**CITY OF
MOUNT DORA, FLORIDA
CITY COUNCIL
MINUTES**

Re: Mt Dora Groves South- US Highway 441
Comprehensive Plan Amendment (AR#4845)
Rezoning (AR#4844) (collectively, the “Dora Groves South Project”)

Mt Dora Groves North- US Highway 441
Comprehensive Plan Amendment (AR#4843)
Rezoning (AR#4842) (collectively, the “Dora Groves North Project”; together with the
Dora Groves South Project, the “Overall Project”)

As counsel to Brochman, LLC, the developer of the Overall Project (the “Developer”), we have reviewed a copy of the proposed letter to Lake County Chairman Sean Parks dated September 27, 2022 (the “September Letter”), which has been added to your public hearing agenda for tonight’s City Council Special Session. It appears that many of these comments were already raised by the City in prior correspondence from the Developer and were responded to by the Developer’s team as set forth in the letter attached hereto as Exhibit “A” (the “Prior Detailed Responses”).

Illustration 15

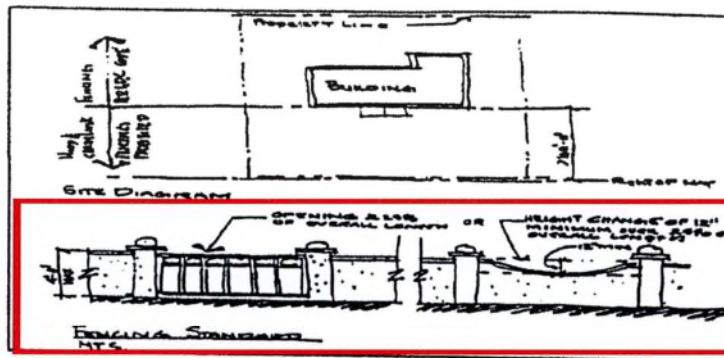
2. As stated in City's previous review pre-cast wall systems are not a design standard in keeping with the high quality expected for developments within Mount Dora. Illustration #15 of Section 6.13 of the City's Land Development Code (wall example next page).

For additional clarification, Mount Dora discouraged community walls type of buffering treatment for residential communities. If walls are so proposed, which is not the City's preference, the materials must be high quality and design with landscaping screening, etc. That is why staff noted the wall material standards in my previous correspondence. For example, the recent Lakeside Waterman Village retirement community provided wright-iron type (I believe the fence is aluminum rails) with stone columns. This type of open fencing tends to be acceptable treatment.

Response: Precast (concrete) wall systems are an industry standard and available in a variety of attractive finishes. The Precast wall systems are a more durable product, easier to repair, more cost effective and come in stone finishes. Regardless of the type of wall that is required, the columns will be spaced at appropriate distances to structurally support the wall or fence.

As shown on the Dora Groves South Project PUD Plan attached hereto as Exhibit "B", the Developer has agreed to build a Precast concrete wall on the west side of the Grandview St. extension and Fiddler Drive extension, which equates to approximately 4,000 linear feet of wall or ¾ of a mile.

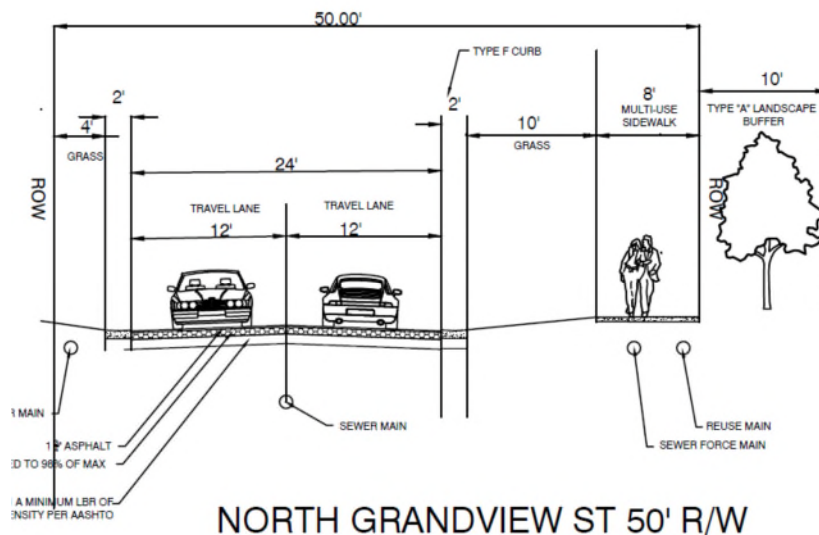
12. The configuration of the intersection improvements necessary for the Limit Avenue and Grandview Street intersection are lacking from the plans. Any proposed improvements require City review and input to assess any potential impacts to the City's planned facilities located on Limit Avenue (Alt Key No. 3916155).

Response: The Developer included the following note on the attached Exhibit "B" plan:

"PROJECT WILL EVALUATE TRAFFIC CALMING MEASURES AT THE INTERSECTION OF LIMIT AVE. AND N. GRANDVIEW ST. WITH LAKE COUNTY PUBLIC WORKS."

Furthermore, there is not enough existing public ROW for a roundabout to be constructed. However, all improvements will be subject to customary transportation improvement requirements in accordance with statutory law at the time of final engineering.

DORA LANDINGS – VINYL FENCE PHOTO 3

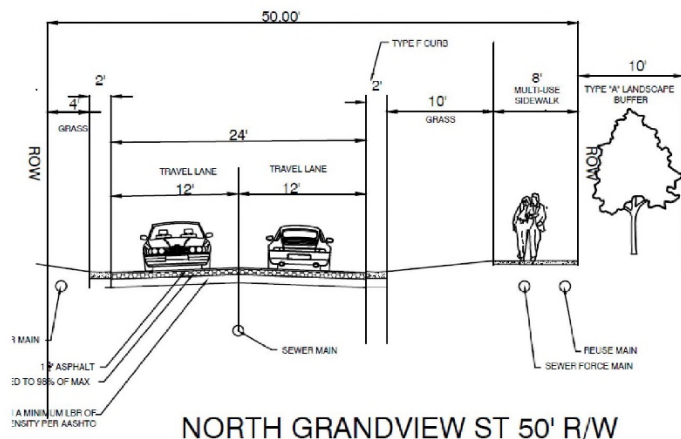
OUR NEIGHBOR TO THE SOUTH, DORA LANDINGS, WAS APPROVED WITH 6' VYNL FENCE (PHOTO 3)
WITH AND CHAIN LINK FENCE (PHOTO 4).

EXHIBIT "E"
DORA GROVES NORTH PROJECT PUD PLAN

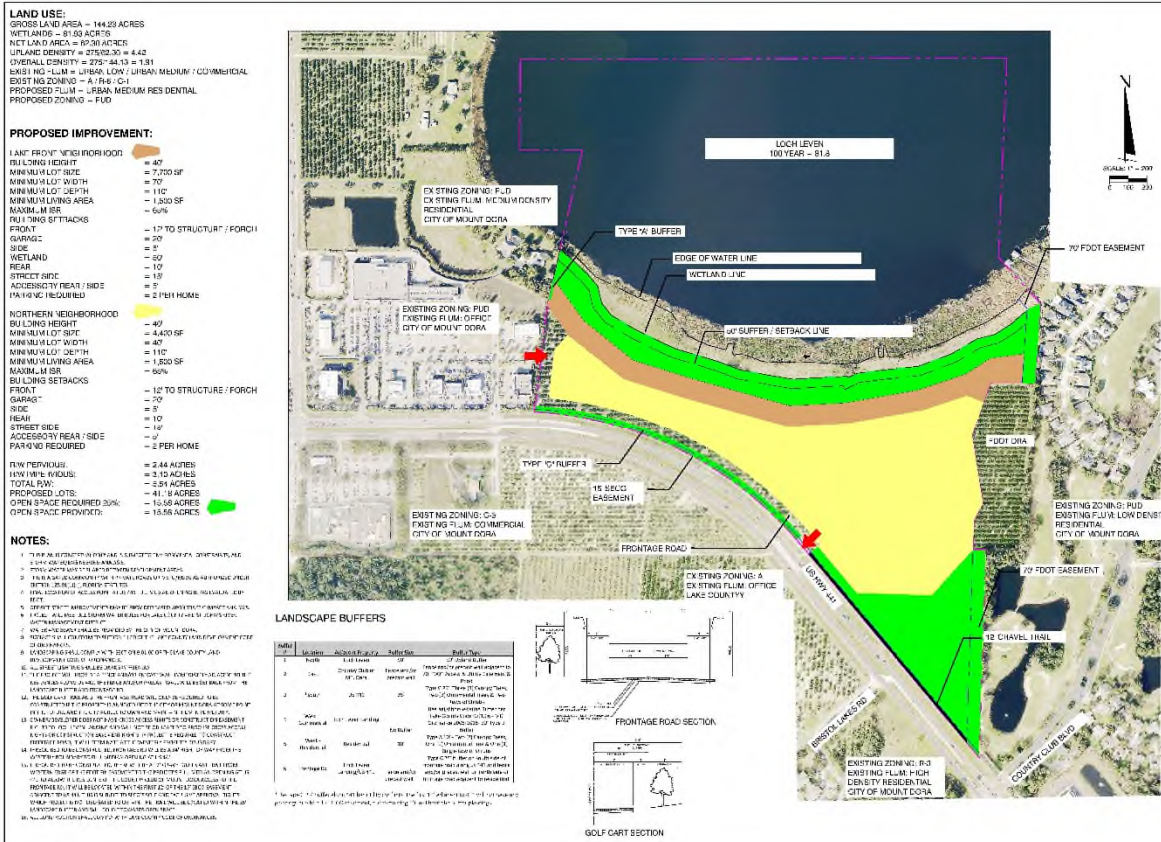
10. **It has been requested for Mount Dora Groves North to provide a multi-use trail (sufficient width to accommodate golf carts) with public access between Loch Leven Landing (Publix) shopping center and the Country Club of Mount Dora Developments. The multi-use trail should be wide enough to accommodate golf carts and the surface material should be either asphalt or concrete; gravel is an unacceptable material.**

11. In lieu of the trail, provide true frontage roadway connecting Country Club Mount Dora to Publix Shopping Center.

Response: Consistent with the legal access and easement rights that exist today, the Developer will only be required to construct a multi-use trail along US 441 from the edge of the existing FDOT

easement (which is situated between our property and the boundary line of the Country Club of Mt. Dora) to the proposed frontage road in accordance with the notes on the PUD Plan for the Dora Groves North Project, attached hereto as Exhibit "E". The Developer will set aside the land for the trail and the City will have the ability to construct such trail to its specifications and maintain the same accordingly as set forth on Exhibit "E".

Response: Consistent with the legal access and easement rights that exist today, the Developer will only be required to construct a frontage road to the Loch Leven Landing Shopping Center (where Publix is located) in accordance with the notes on the PUD Plan for the Dora Groves North Project, attached hereto as Exhibit "E".
